# Village of La Grange

PLAN COMMISSION  
of the  
VILLAGE OF LA GRANGE

**Tuesday, June 10, 2014 - 7:30 p.m.**

RE: SPECIAL USE/SITE PLAN APPROVAL TO ALLOW OUTDOOR SEATING/  
Kama Indian Bistro in the C-1 Central Commercial District, 9 S. La Grange  
Road.

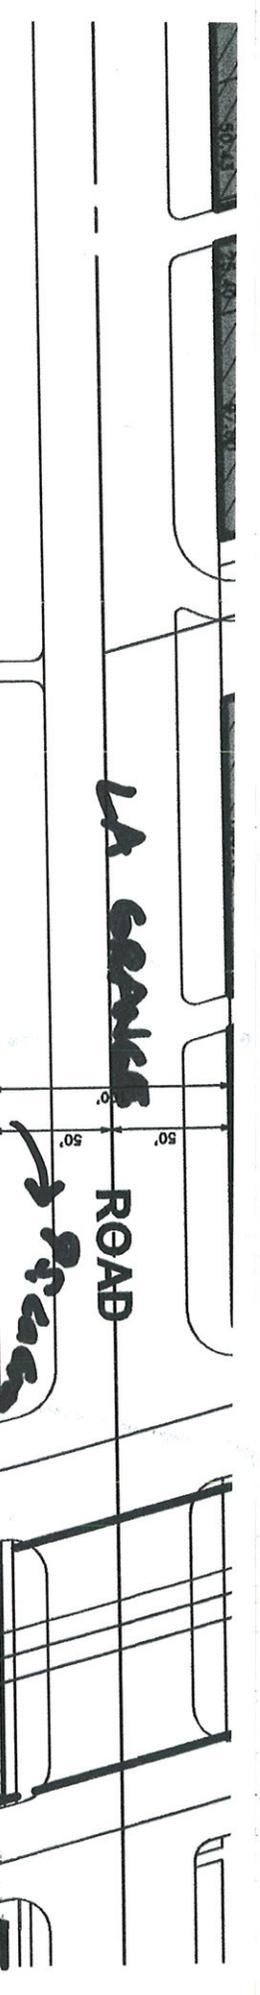
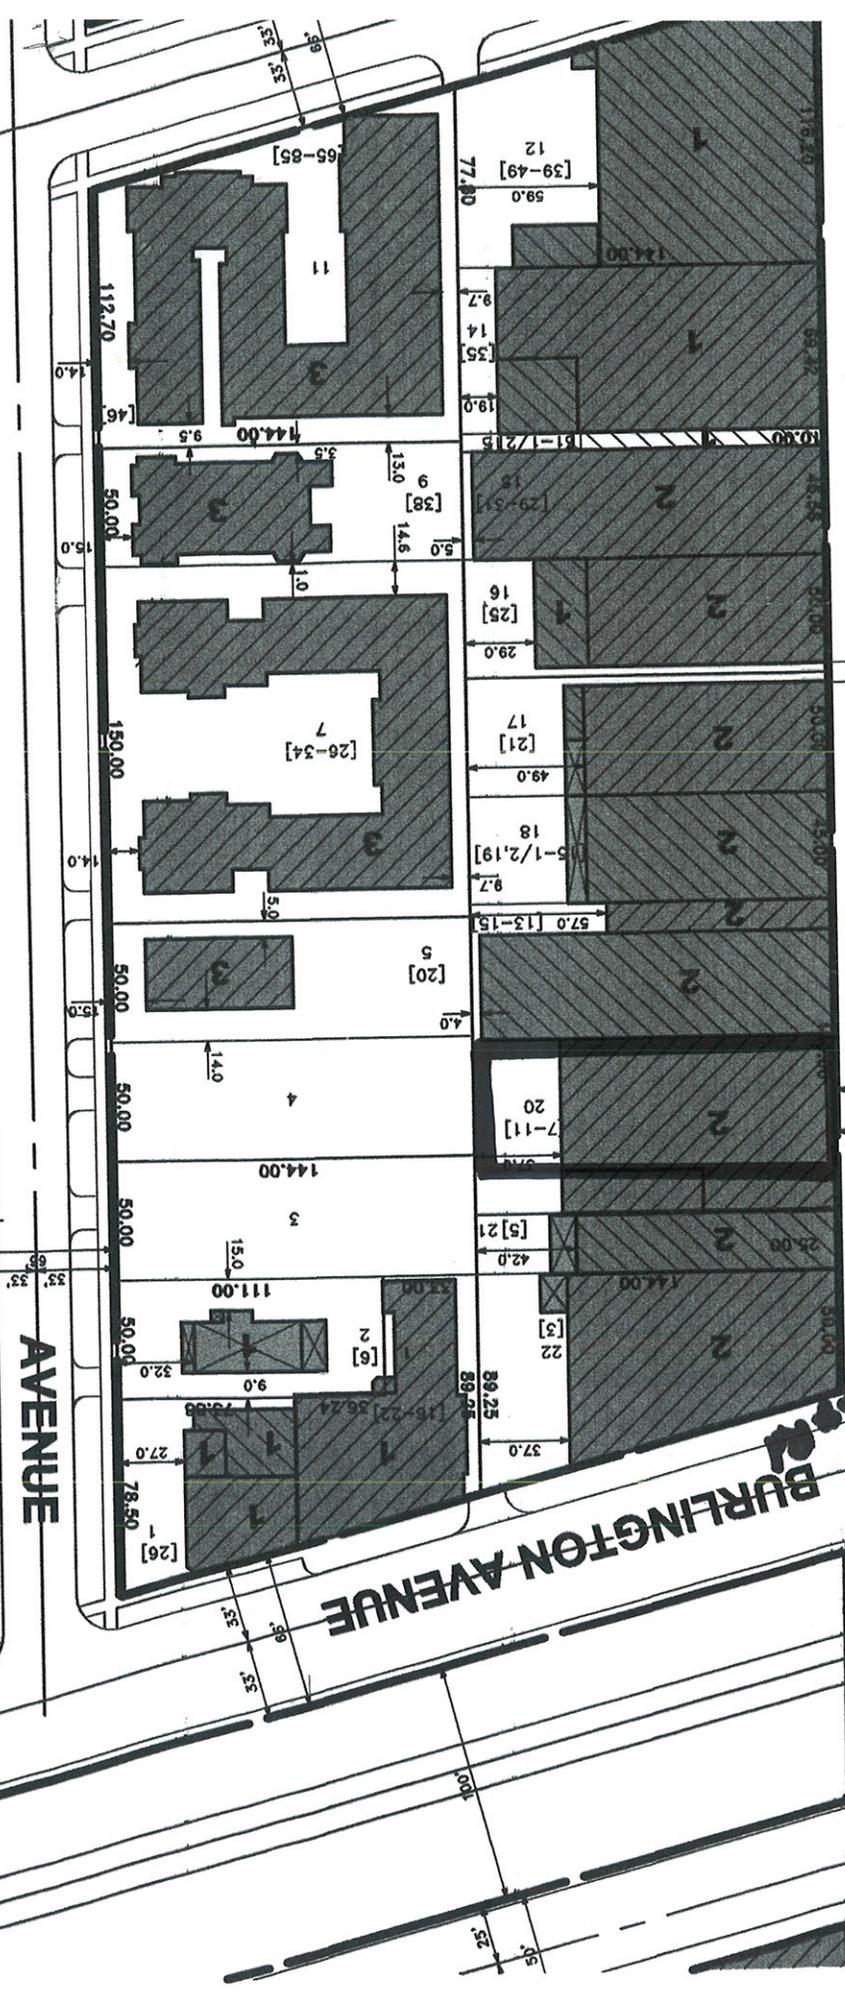
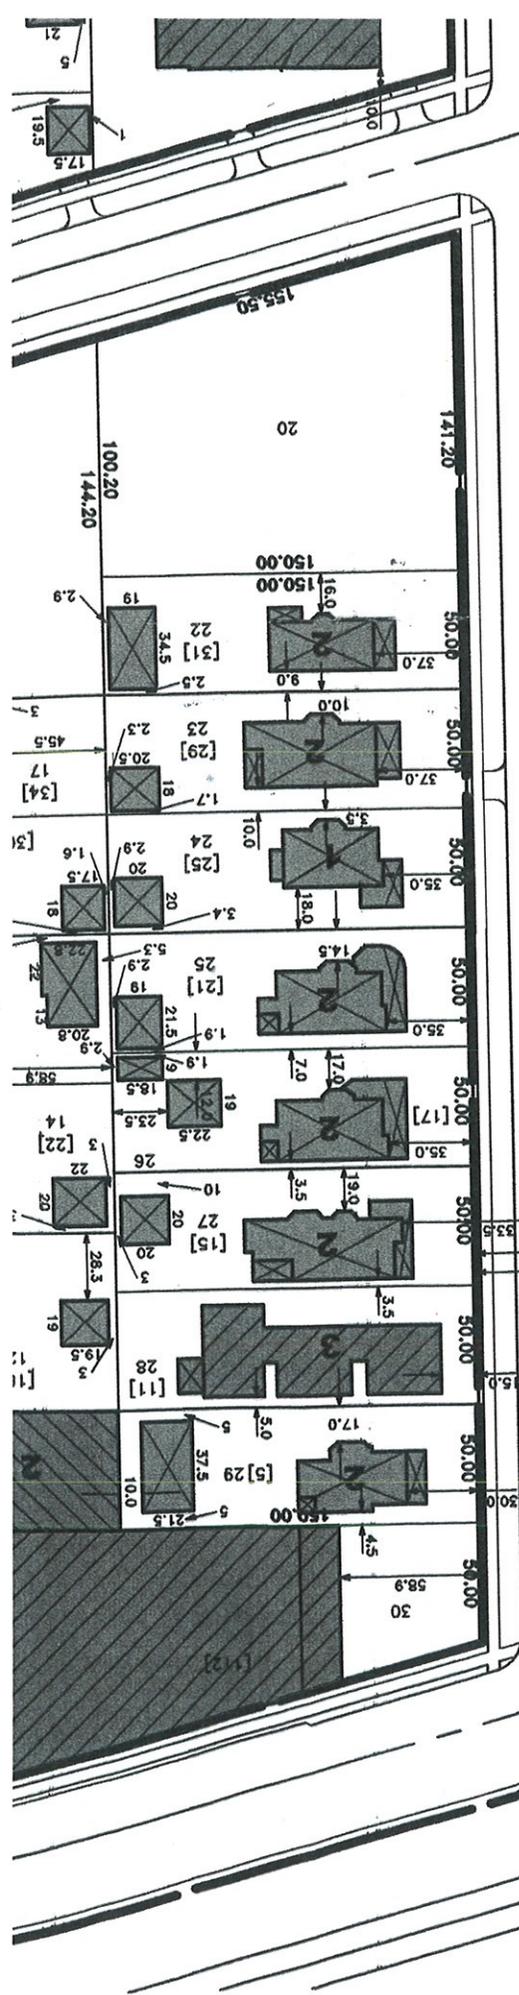
Attached are images of the proposed design and materials. According to the applicants, the designer/contractor for the outdoor patio has designed an award-winning top rated patio in Chicago. (See attached exhibits provided by the Applicants.) The Plan Commission should discuss and determine whether or not the appearance of the proposed structure is consistent with other areas directly on the alley.

- (3) Hours of operation for the outdoor seating area to be limited to the hours between 10:00 a.m. and 11:00 p.m. on weekdays and 10:00 a.m. and midnight on weekends.; and
- (4) Construction and operation of the outdoor eating area to comply with all applicable local and state codes relating to building, food service construction and sanitation; and
- (5) Provide proof of overnight parking for residences; and
- (6) All dumpsters be fully enclosed and provide a contract to the Village to be kept in force for the life of outdoor eating area for daily removal of refuse and recycling; and
- (7) Adequately support the fence in anticipation that snow will be pushed up against the fence given the closeness of the proposed fence existing alley.

PC #218 - Lane Bishe

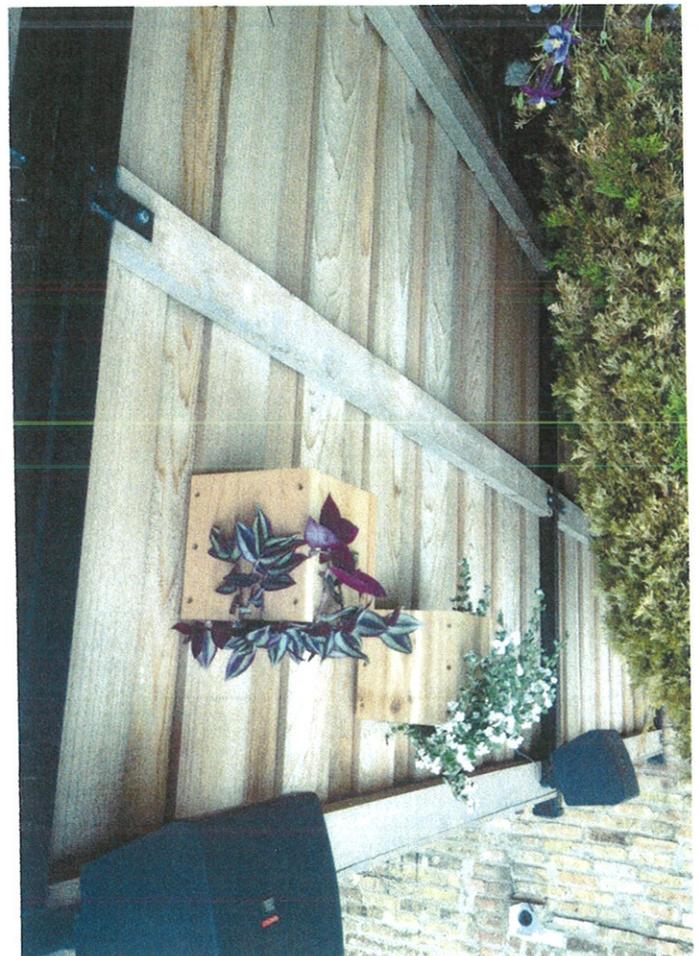
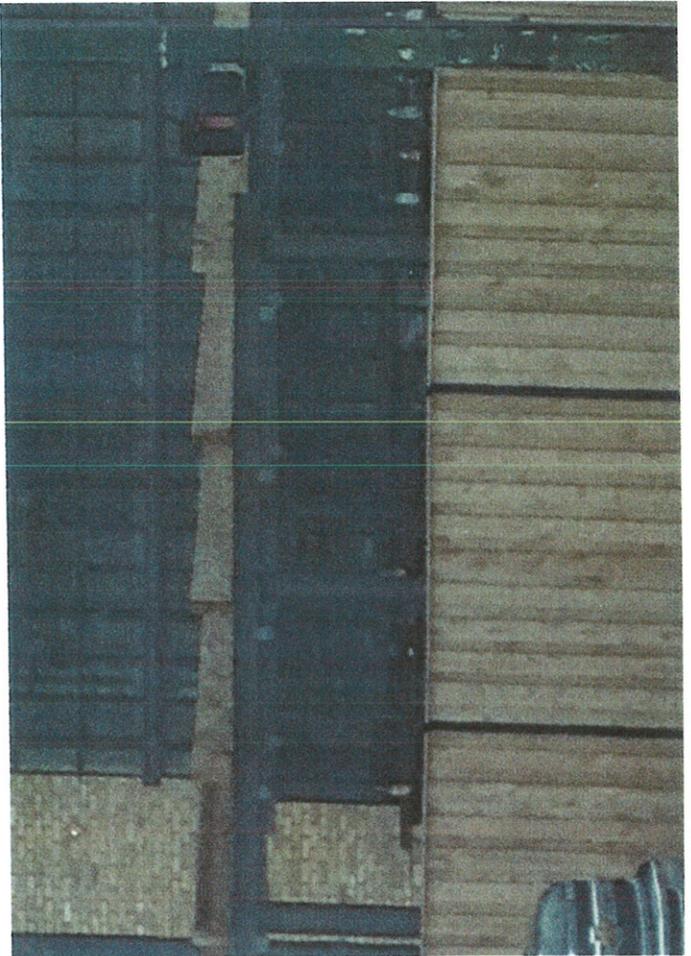
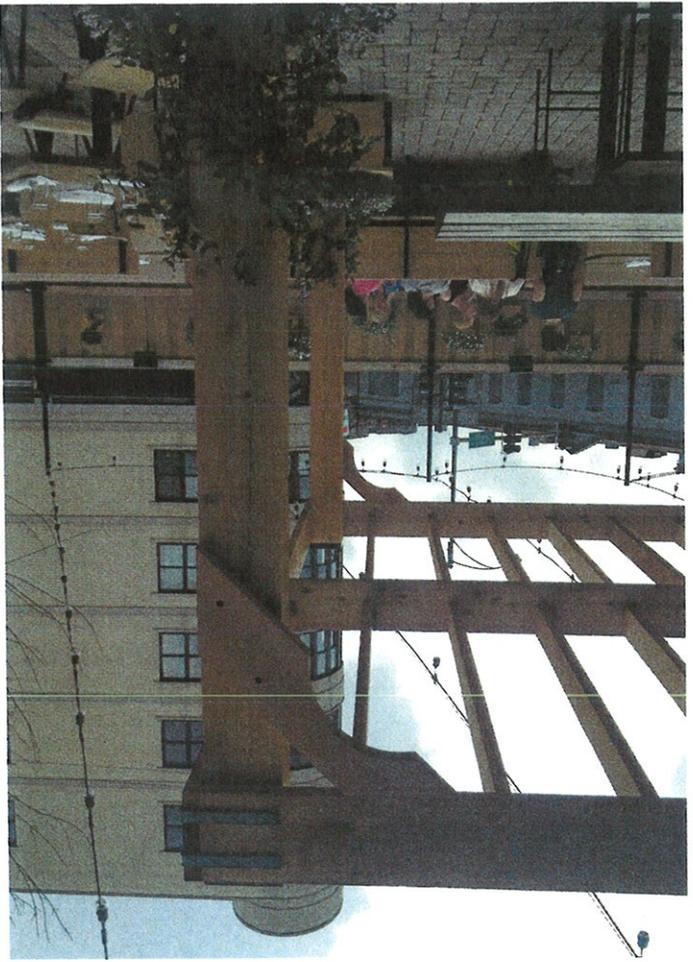
↑ dumpsters will be moved to enclosure and daily pickup
